# CRMC DECISION WORKSHEET

2021-10-077

Bennett Family Irrevoc. Trust

DATE: 27 January 2022; last revised 2 March 2022  
TO: Jeffrey M. Willis, Executive Director  
FROM: T. Silvia, Permit Staff  
SUBJECT: CRMC File No. 2021-10-077

**BUFFER ZONE MANAGEMENT MITIGATION PLAN**

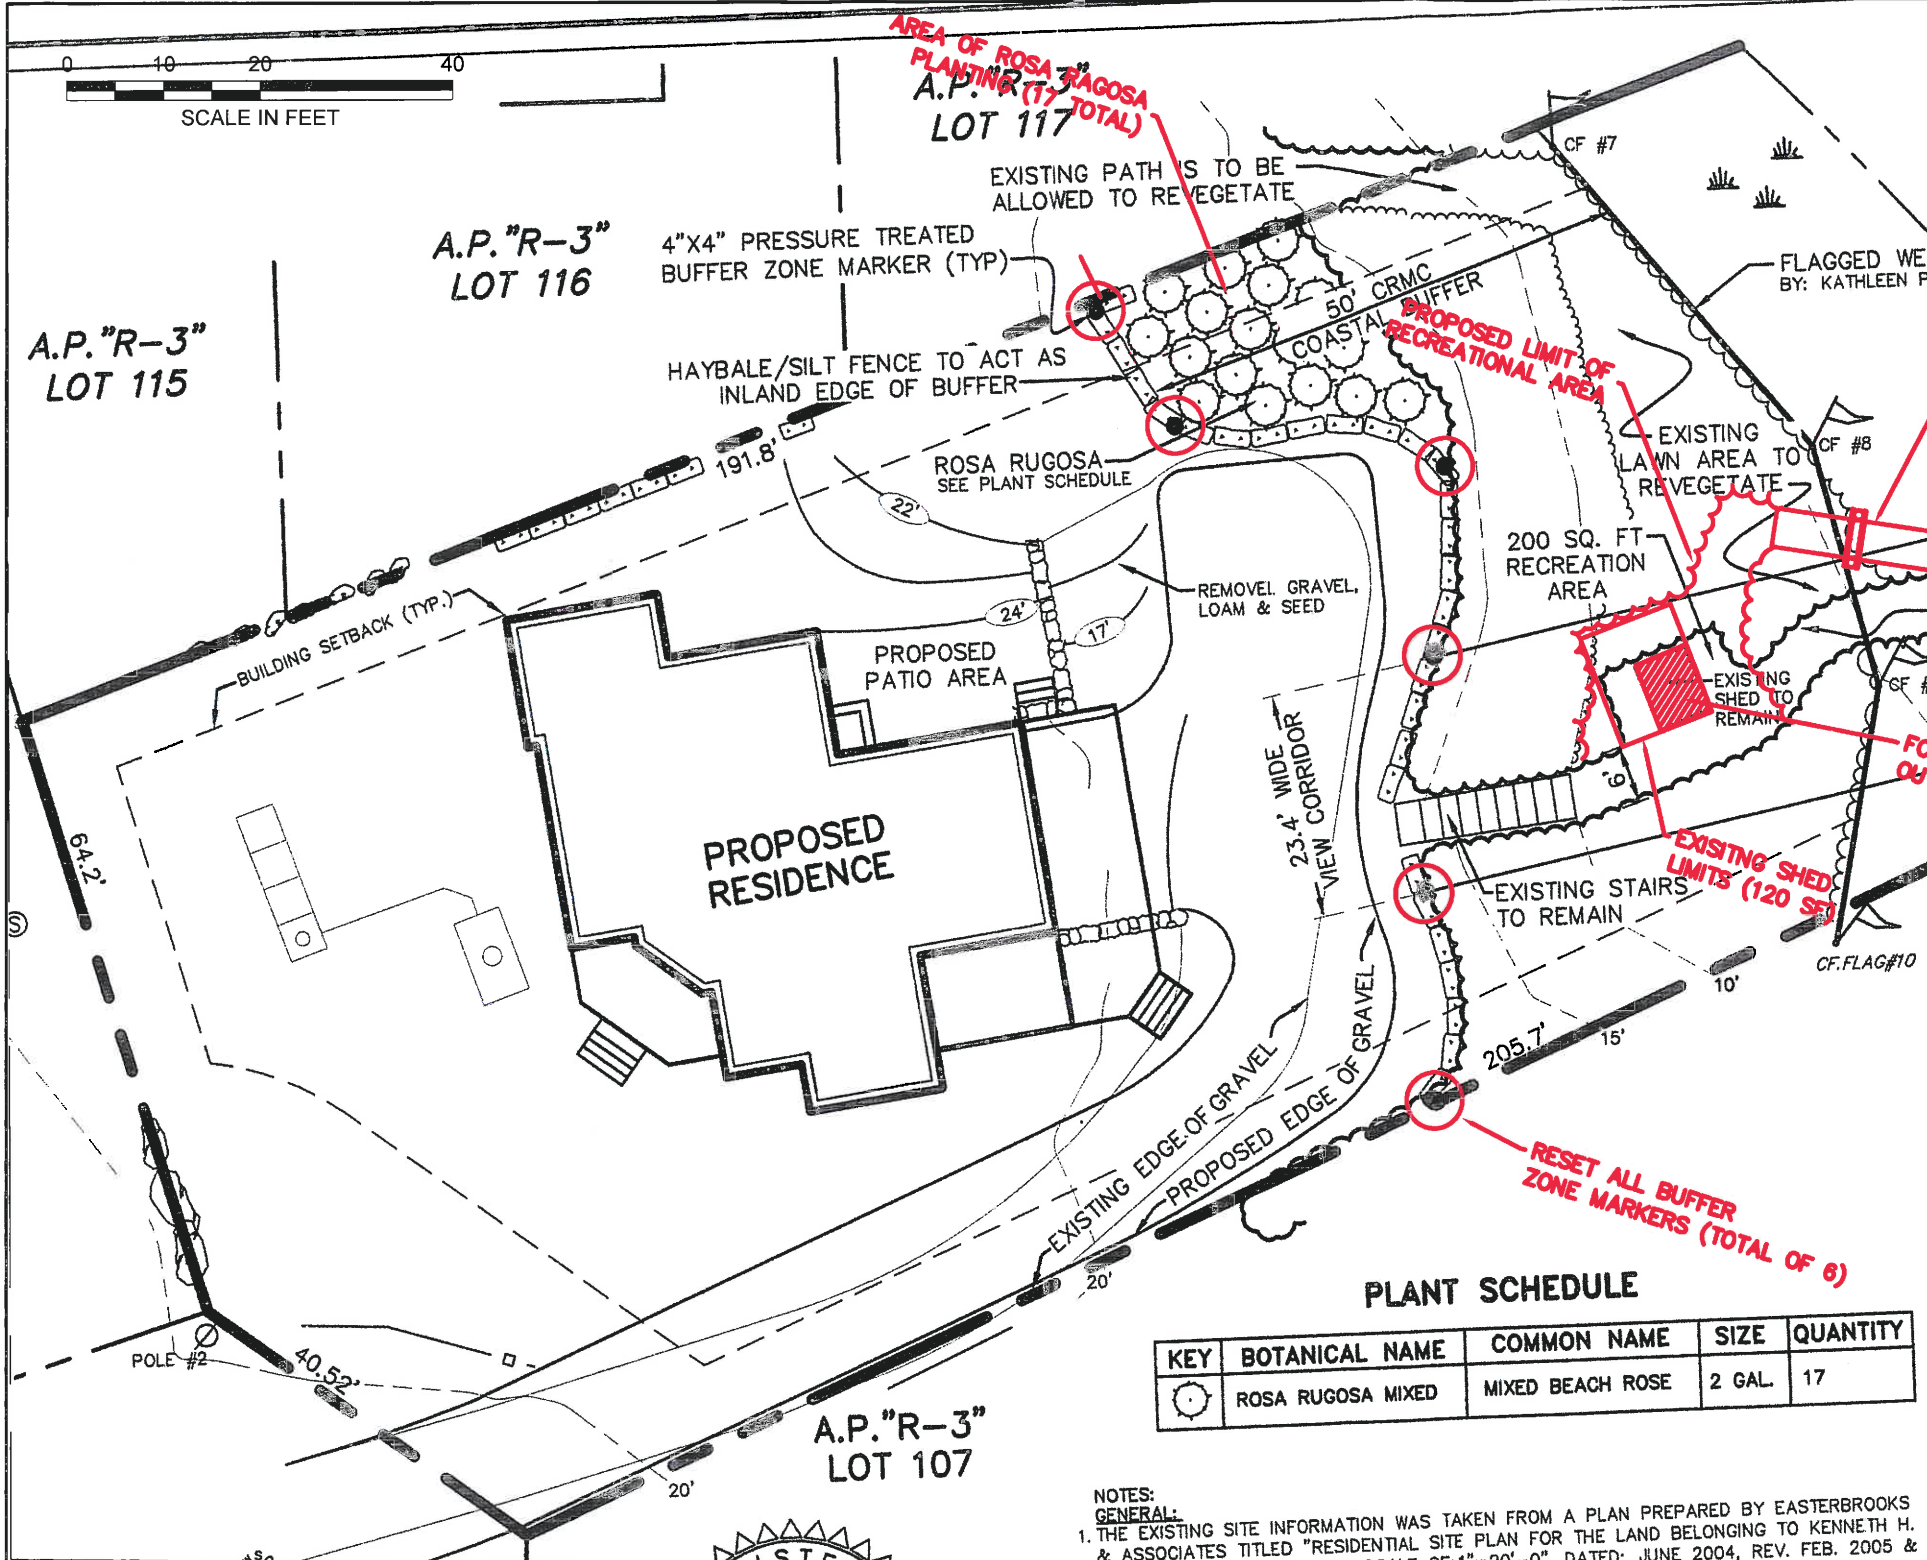
7. The applicant has addressed the buffer zone restoration through a recent submittal of a planting and demarcation plan, which requires permanent markers, previously required planting installation and an area to revegetate following dock construction. Staff concurs with the proposed restoration and compliance monitoring will follow.

8. The project has signoffs from the affected abutters, with no comments submitted during public notice. Although a large length variance is required, the project is designed similar to nearby permitted structures based on existing environmental conditions. The applicant has provided variance burdens of proof which staff believes represents a minimization of the request and the proposed restoration will lessen current wetland impacts. Staff recommends approval of the application with standard stipulations held pending Council's decision. Additionally, a planting deadline of May 15, 2022 will be stipulated, of which the applicant is aware.

Buffer plantings to be installed no later than May 15, 2022
